Preliminary Plan, 120110150: Stoney Creek Road

Preliminary Plan No. 120110150: Stoney Creek Road

Staff Recommendation: Approval with conditions and adoption of the Resolution.

PRELIMINARY PLAN OF SUBDIVISION
DELL PROPERTY
STONEY CREEK ROAD
PARCEL P165
6TH ELECTION DISTRICT - MONTGOMERY COUNTY - MARYLAND

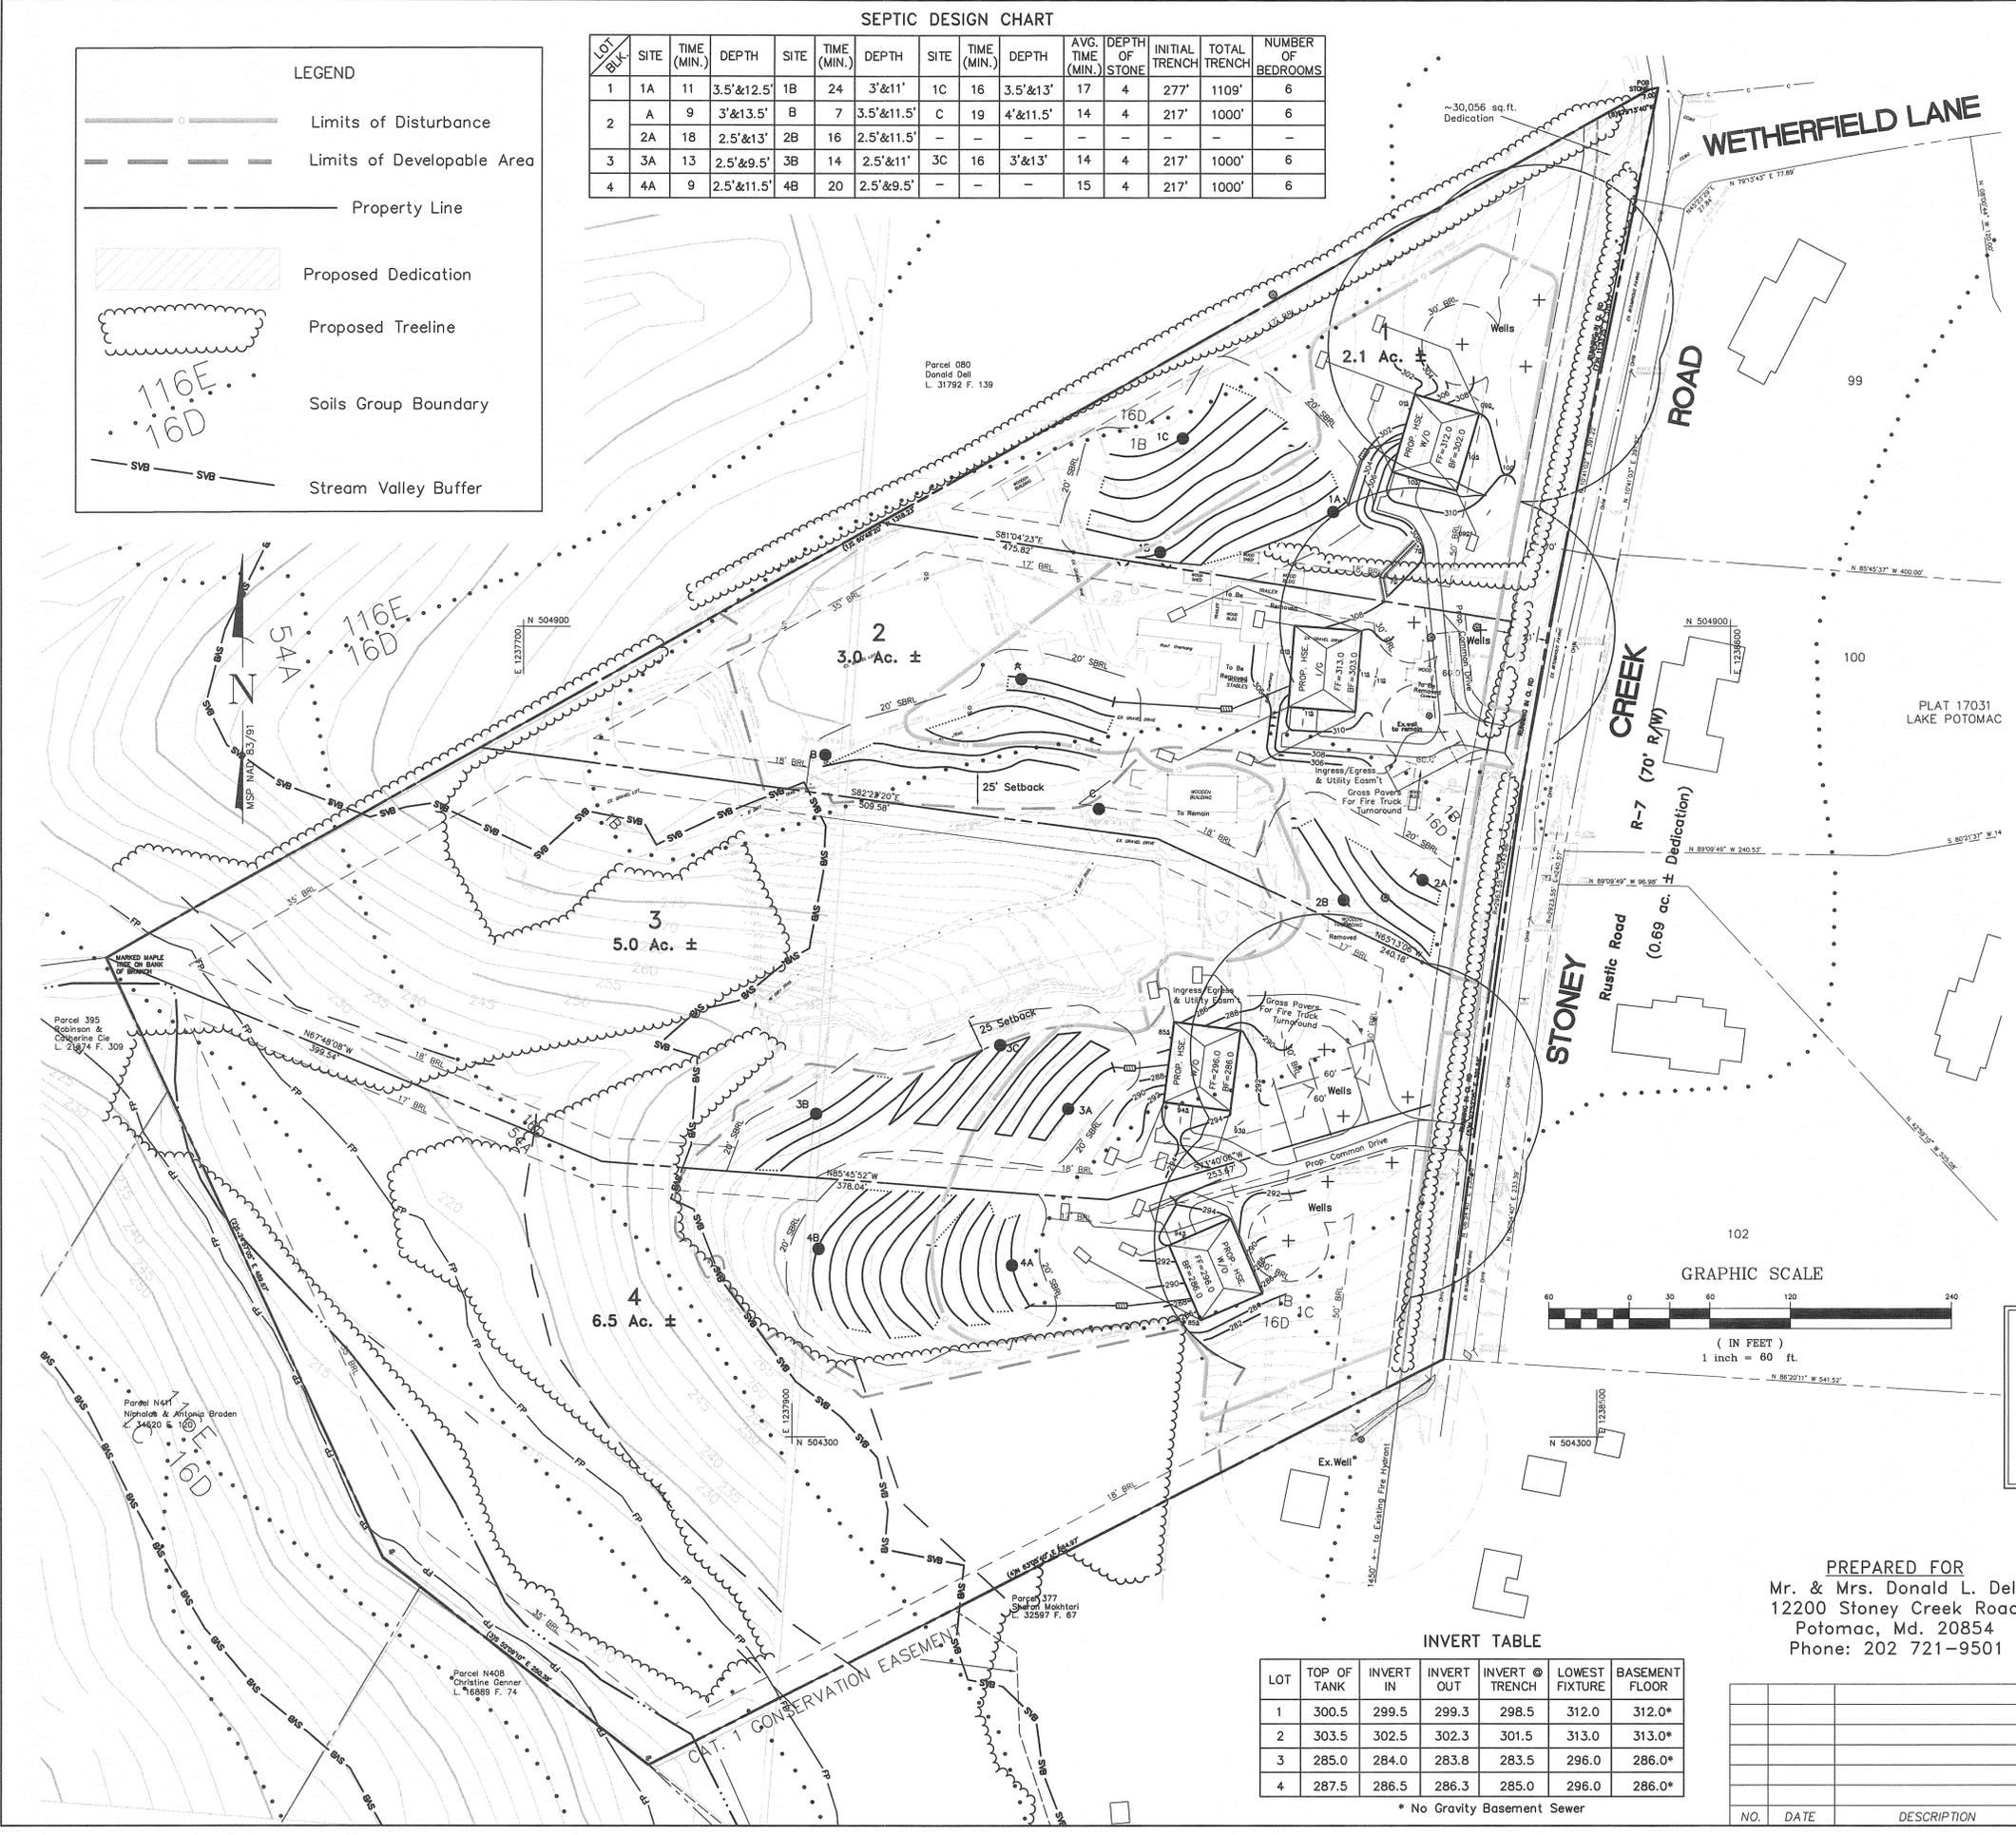
- a. The final forest conservation plan must be consistent with the Preliminary Forest Conservation Plan and address the following:
 - i. A revised limit of disturbance to accommodate repair of the eroded channel as specified in a Soil Erosion and Sediment Control/Stormwater Management Plan required by the Montgomery County Department of Permitting Services – Water Resources Section approval letter dated March 17, 2011.

- ii. Show the removal of all impervious surfaces (including gravel) within the Category I conservation easement area and revise the limit of disturbance to accommodate those changes.

- 7) The Applicant must dedicate and show on the record plat(s) the dedication of their portion of the 70 foot wide right-of-way for Stoney Creek Road as measured from the opposite right-of-way line.
- 8) The record plat must reflect common ingress/egress and utility easements over all shared driveways.
- 9) The approved Preliminary Plan must contain the following note:

SWM CONCEPT & SITE DEVELOPMENT PLAN
DELL PROPERTY
STONEY CREEK ROAD
 PARCEL P165
 6TH ELECTION DISTRICT - MONTGOMERY COUNTY - MARYLAND

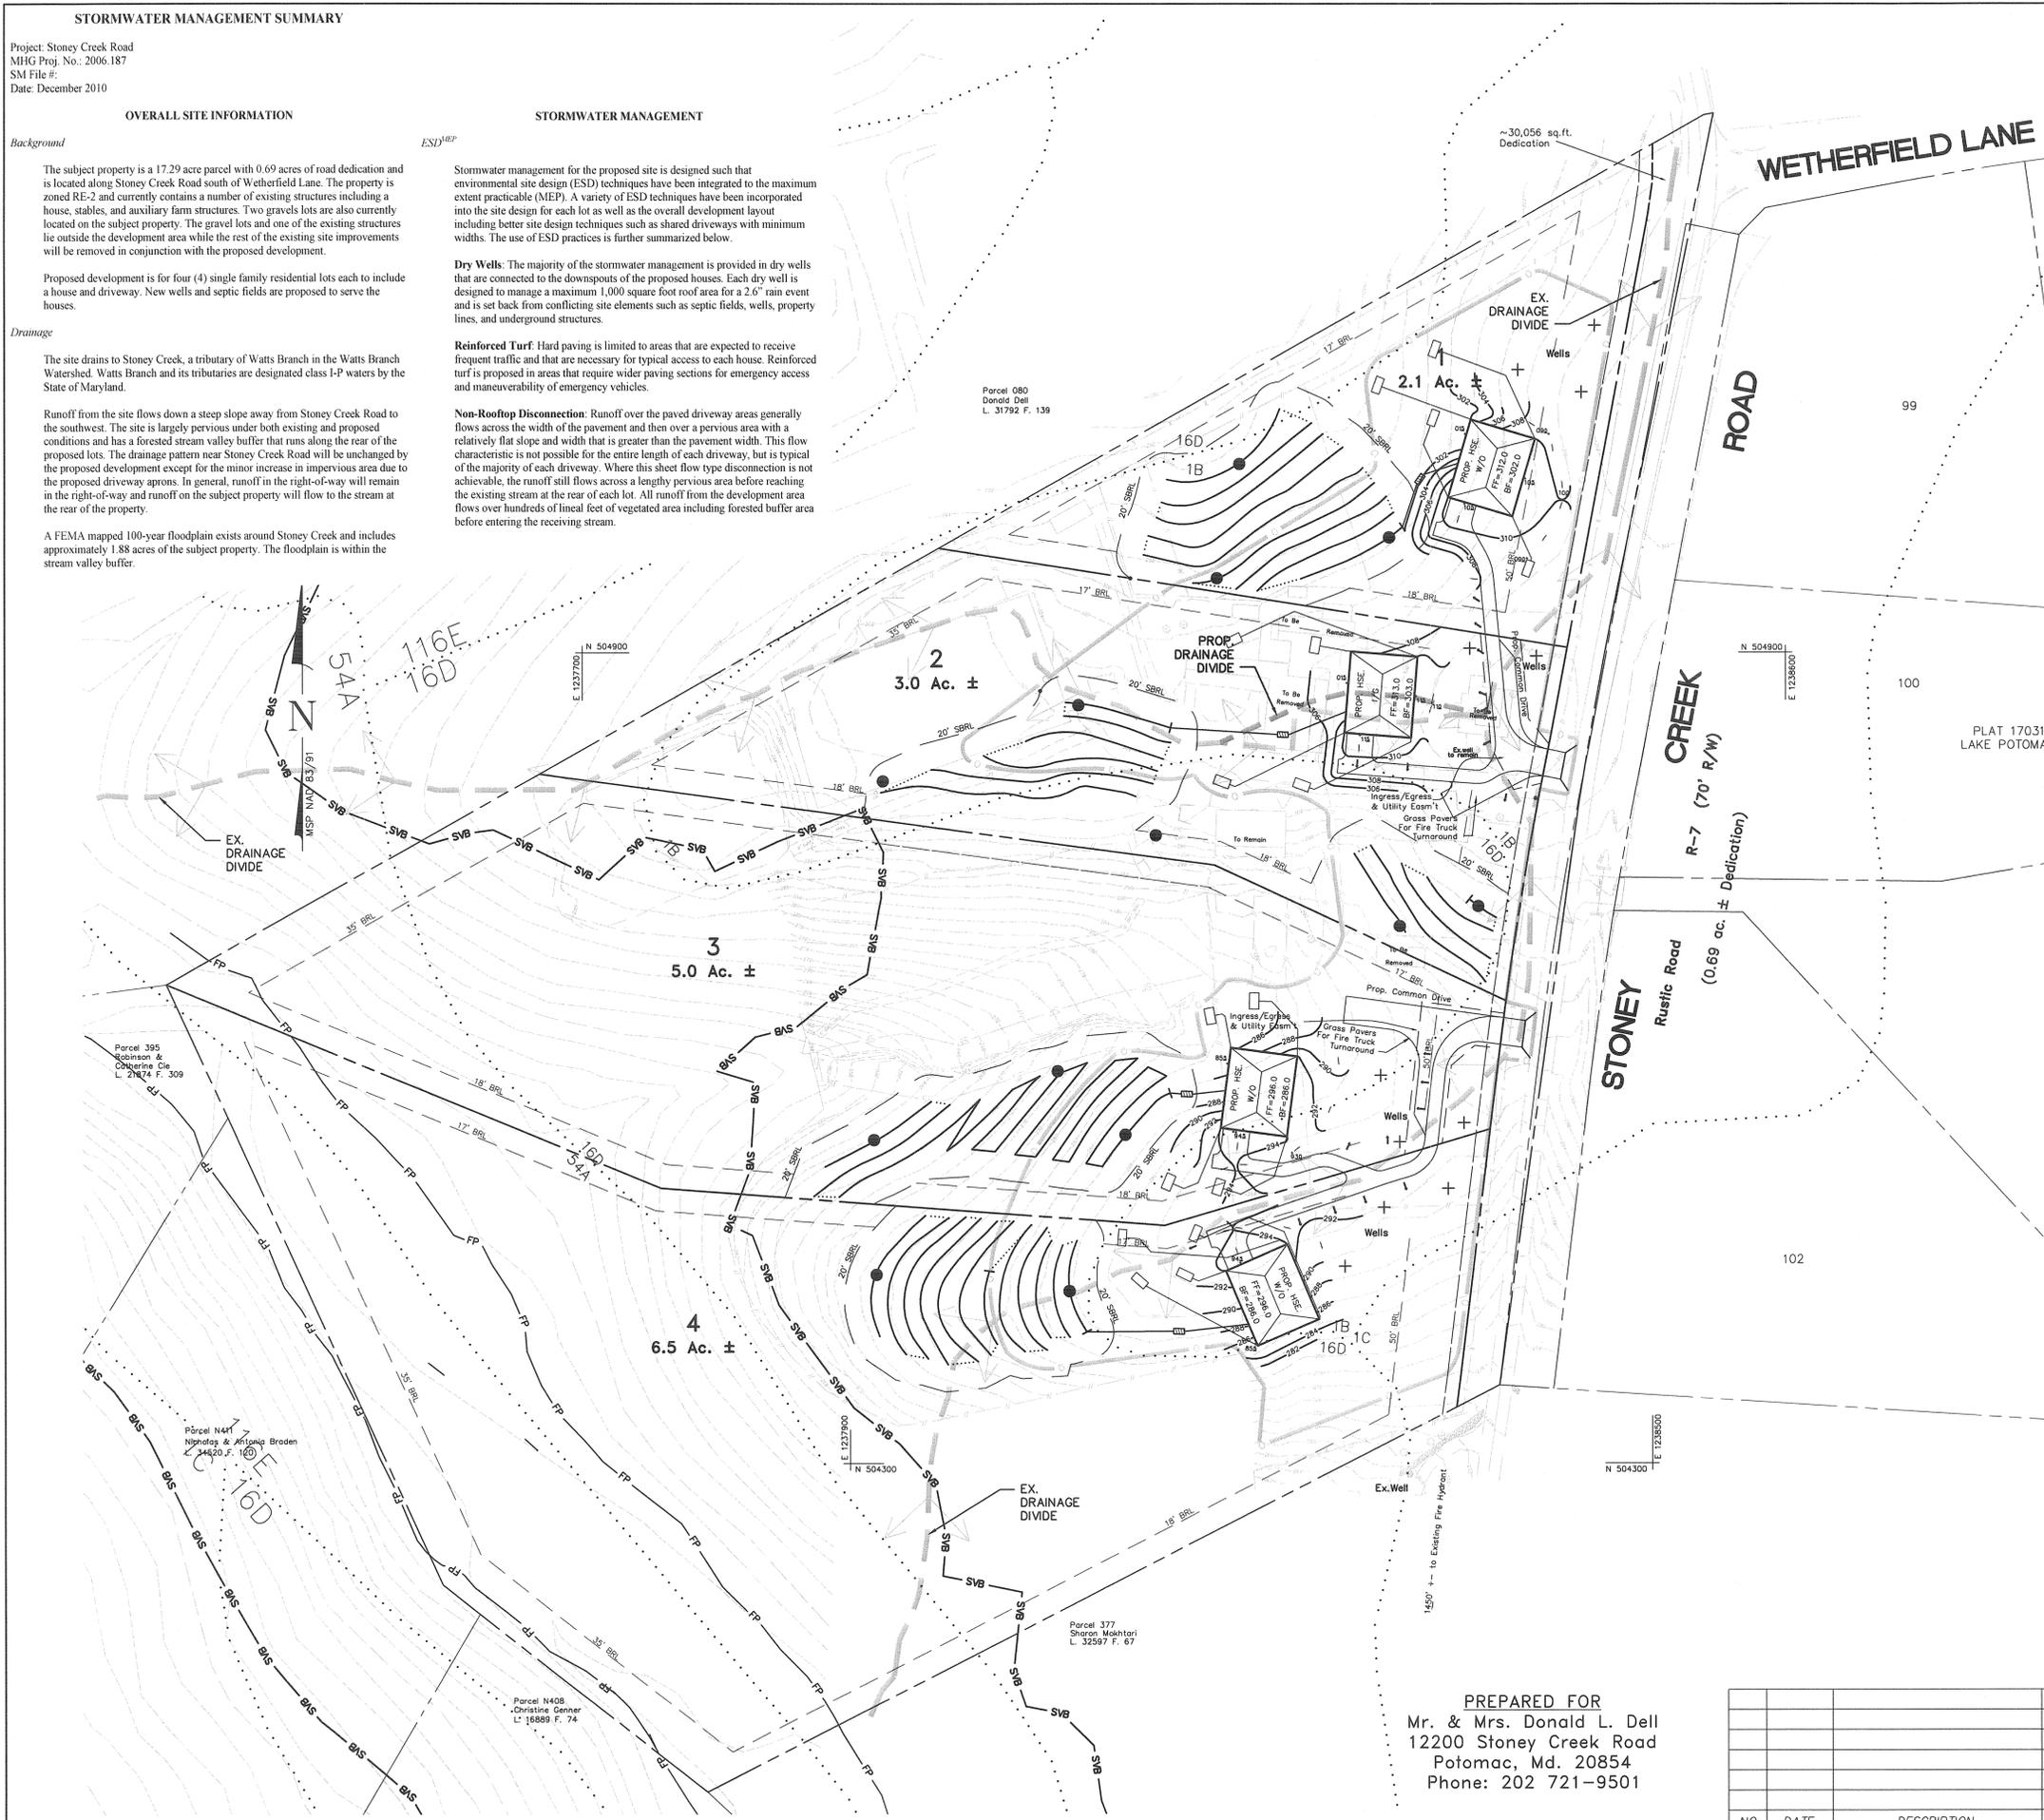
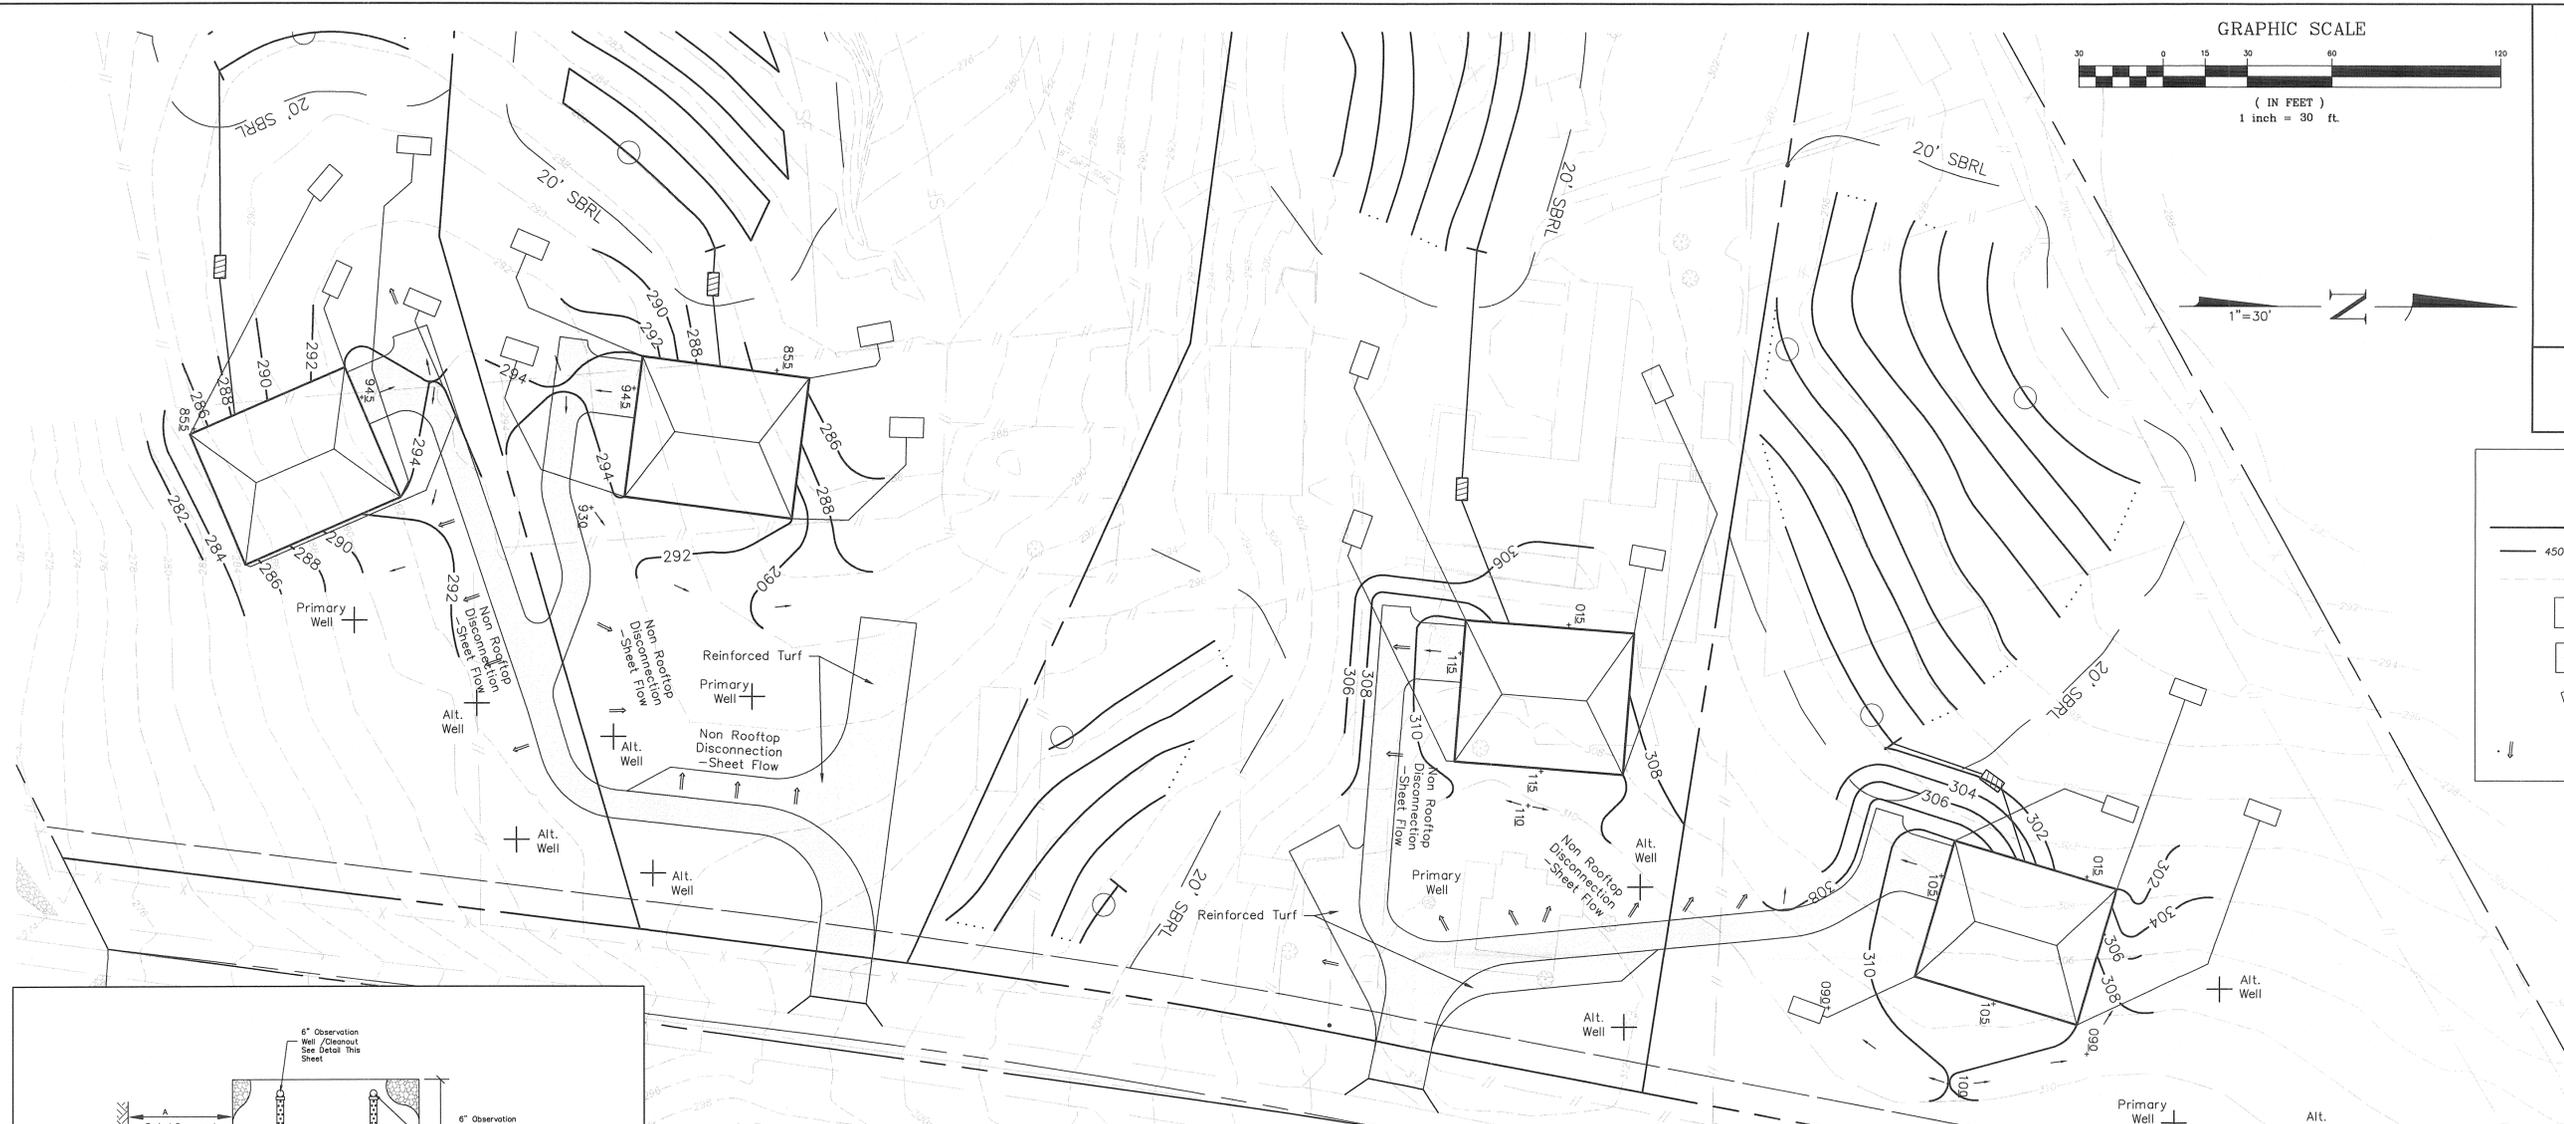
The MCDPS Stormwater Management Section conditionally approved the stormwater management concept for the project on March 17, 2011. The concept requires that the severe erosion on proposed Lot 3 must be repaired and safe conveyance of the flows provided. Staff has recommended that the Final Forest Conservation Plan show the appropriate limit of disturbance to allow the work to be done in the area of the eroded channel. Environmental Site Design was integrated on-site using techniques such as overall site design and shared minimum-width driveways. Other on-site water quality mitigation will be provided through non-rooftop disconnects and dry wells.

1. Prior to permanent vegetative stabilization, all disturbed areas must be topsoiled per the latest Montgomery County Standards and Specifications for Topsoiling.
2. A detailed review of the stormwater management computations will occur at the time of detailed plan review.
3. An engineered sediment control plan must be submitted for this development.
4. All filtration media for manufactured best management practices, whether for new development or redevelopment, must consist of MDE approved material.
5. Prior to Record Plat approval the extensive erosion on proposed lot 3 must be repaired and safe conveyance of the flows provided.
